Docket #(s): SW-20769A-10-0469

Arizona Corporation Commission

IN THE MATTER OF THE
APPLICATION OF WICKENBURG
RANCH WASTEWATER, AN ARIZONA
LIMITED LIABILITY COMPANY, FOR A
CERTIFICATE OF CONVENIENCE AND
NECESSITY TO PROVIDE
WASTEWATER SERVICE IN YAVAPAI
COUNTY

APPLICATION FOR A
CERTIFICATE OF CONVENIENCE
AND NECESSITY

Attachment 6

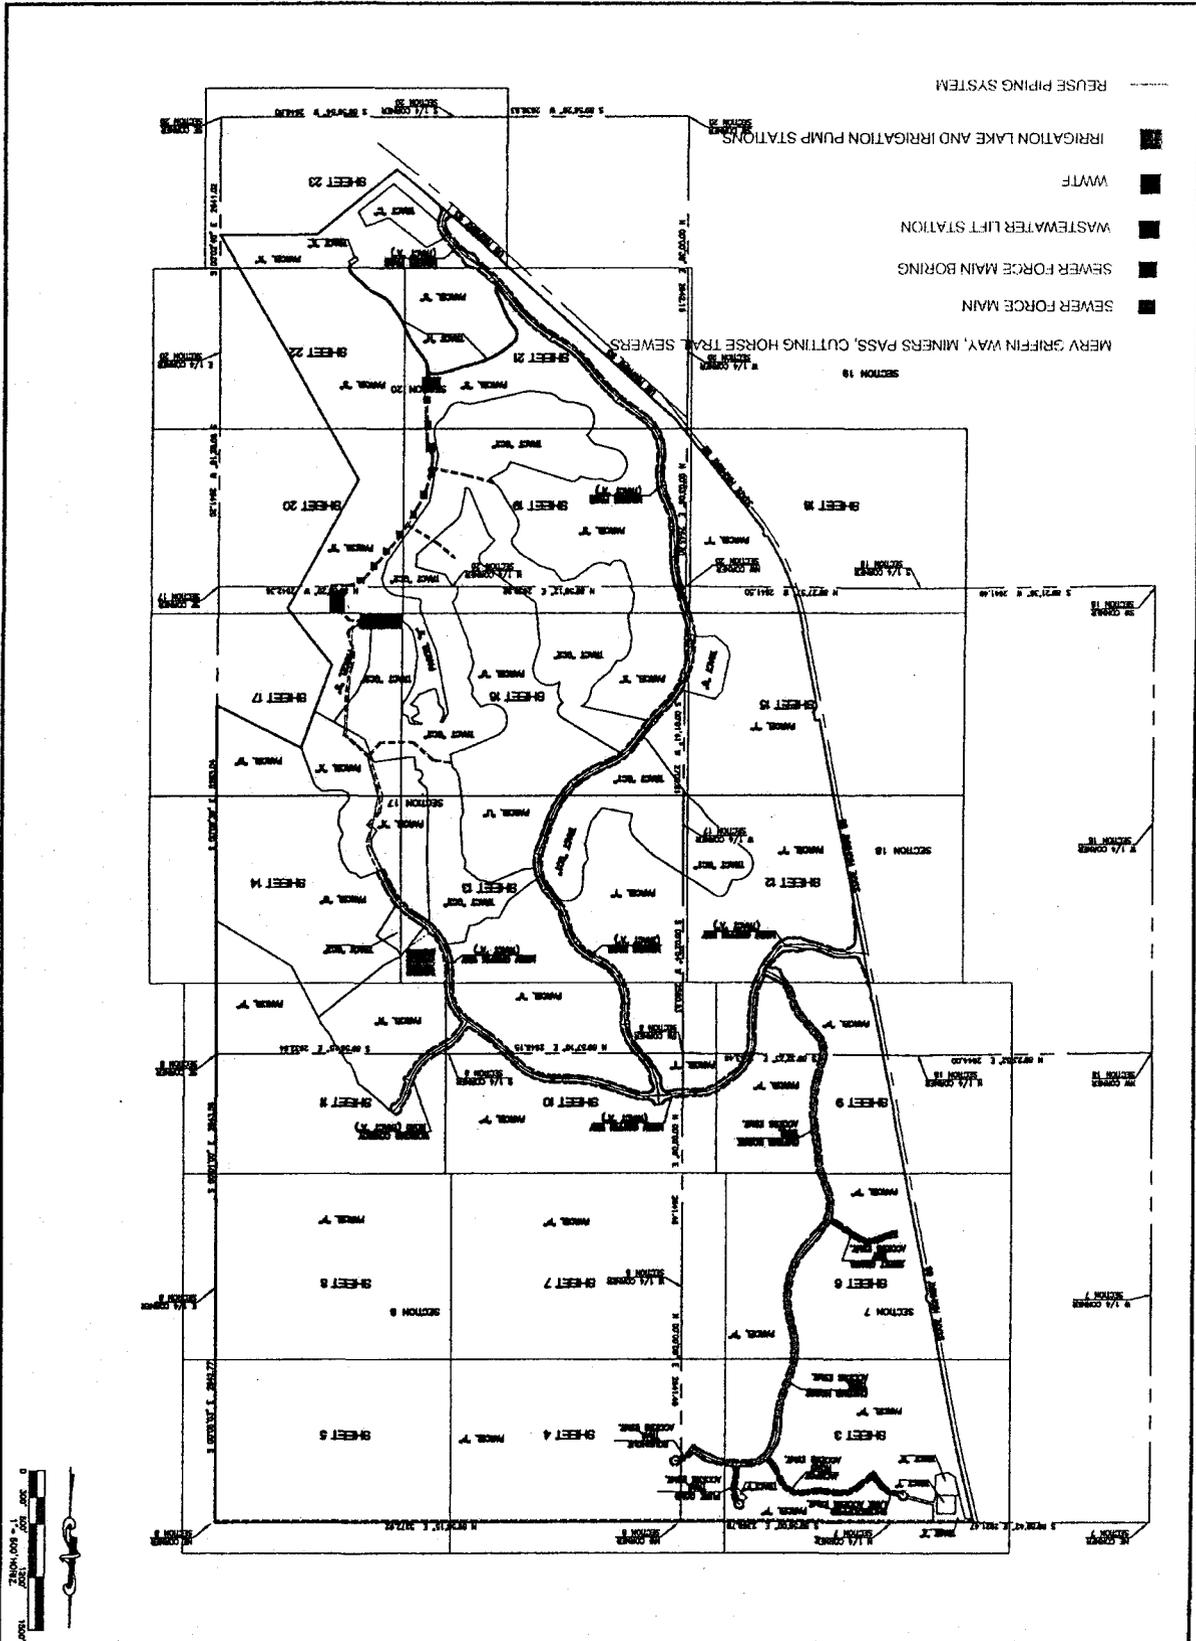
1 h. Please provide a corresponding map clearly identifying location of the
2 proposed major wastewater components listed in Exhibit 5. For example, clearly identify
3 location of Merv Griffin Way, Miners Pass, Cutting Horse Trail sewers, Force Main
4 Boring, wastewater lift station, force mains, WWTF, irrigation pumps station, irrigation
lake, reuse piping system;
